# Palmdale to Burbank Project Section

Appendix 3.4-A Elevated Wentworth  
Street

### TECHNICAL MEMORANDUM

To: Scott Steinwert and John Cook, Circlepoint  
From: Lance Meister and Scott Edwards, Cross-Spectrum Acoustics Inc.  
Date: March 29, 2018  
Subject: CAHSR Palmdale-Burbank – Elevated Wentworth Street Design Change  
Reference: CSA Project No. J2014-1470

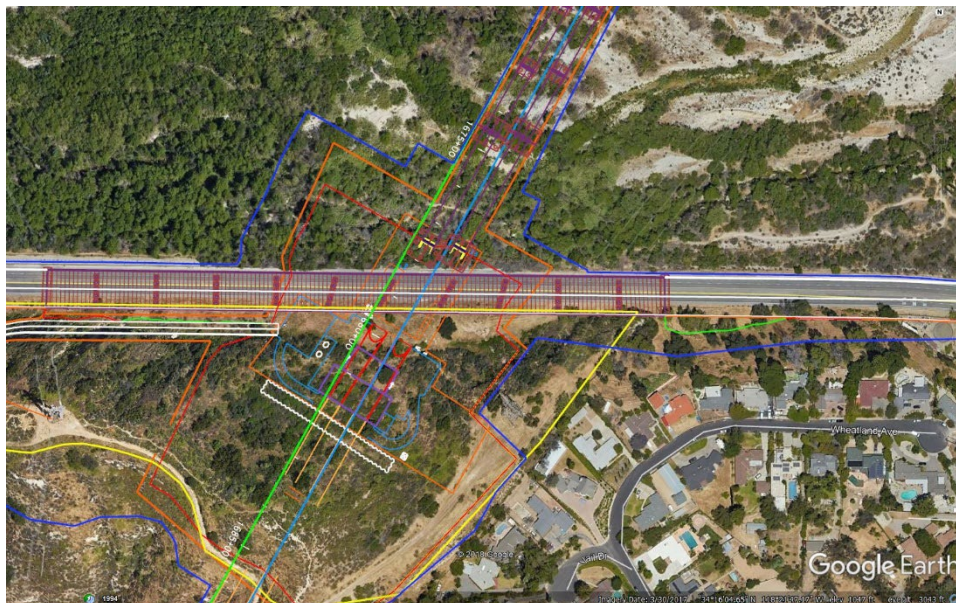
Figure 1, below, shows the proposed design change of Wentworth Street on an aerial structure passing over the proposed Alignment E2 and E2A. Elevating the existing traffic noise would result in a change to the noise environment for nearby noise-sensitive receivers on Wheatland Avenue and Vail Drive shown in Figure 2.

- Noise from traffic on Wentworth Street would increase by a maximum of 0.3dB due to the road being elevated by as much as 30ft above the existing profile of Wentworth Street at the point of closest approach to noise-sensitive receivers,
- Noise from CAHSR operations would decrease by approximately 0.2dB due to the additional shielding of CAHSR noise provided by the elevated roadway structure,

- The net increase in noise would be 0.1dB or less, and
- There would be no change in the predicted number of noise effects in this area (Wentworth Street to McBroom Street). Moderate and severe noise effects are projected in this area at 10 residences and two residences, respectively, on the northbound side of the tracks. These effects would be due to the proximity of the receivers to the proposed track on aerial structure and the speed of the train.
